## Designers Response to Road Safety Audits for Access Strategy

The proposed interventions suggested within the Transport Assessment produced to support the Planning Application have been subject to a Road Safety Audit dated January 2016 produced by Head Mann Associates. This note represents the Designers Response to the Stage 1 Audit.

Westbound entry to the 'service road' would be from a right-turn centre lane. The turn centreline radius would be a tight 4.5m approx. – vehicles might not make the turn in one movement and have to reverse back into Haverhill Road in the face of oncoming traffic. Eastbound exit from the 'service road' would require vehicles to make a manoeuvre with a turn centreline radius of only 3m approx. if such turning vehicles are not to transgress into opposing traffic lanes/flows. In summary, the junction geometry is too tight.

**Figure 2a: Chalkstone Way Access**

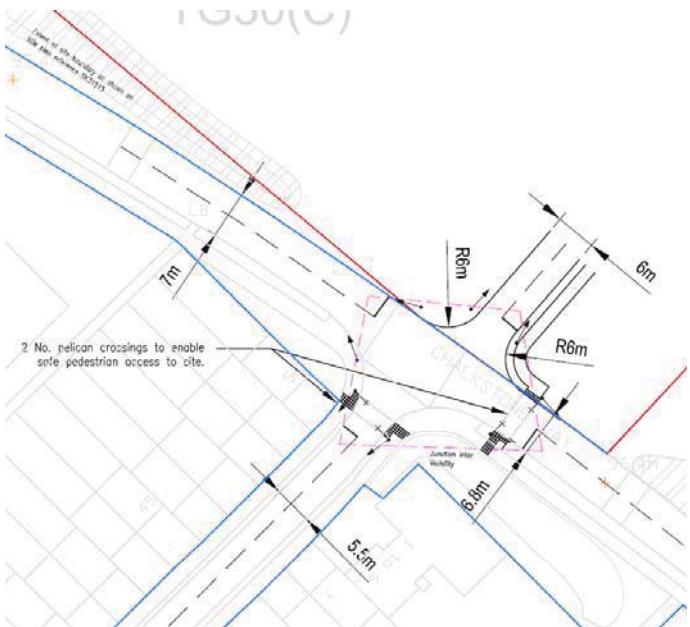
The primary signal heads adjacent to the pedestrian crossing facilities have been drawn in incorrect locations and the intervisibility zones drawn incorrectly. Secondary signal heads might be better-placed on the opposite sides of the junction. Although the foregoing are, perhaps, more matters of detail that might be expected to be considered at detail design stage the Auditors are concerned that when drawn correctly the intervisibility zones would appear to cross over what might be third-party lands.

The Auditors have concerns that with NMU crossing facilities as at the signalised junction there would be inconsistencies with raised table courtesy/Zebra crossings provisions elsewhere along Chalkstone Way. There would also be risks that pedestrians might cross ‘against’ vehicular ‘green light’ movements at times of lower traffic flows. Later ‘Comment 4’ relates.

**Designer's Response:** *The main entrance to the site will be via the proposed roundabout to the north east of this junction. It is anticipated that the majority of long vehicles will utilise the roundabout in preference to this junction. Swept path analysis has been carried out and refuse vehicles can negotiate this junction layout without clipping the kerbs.*
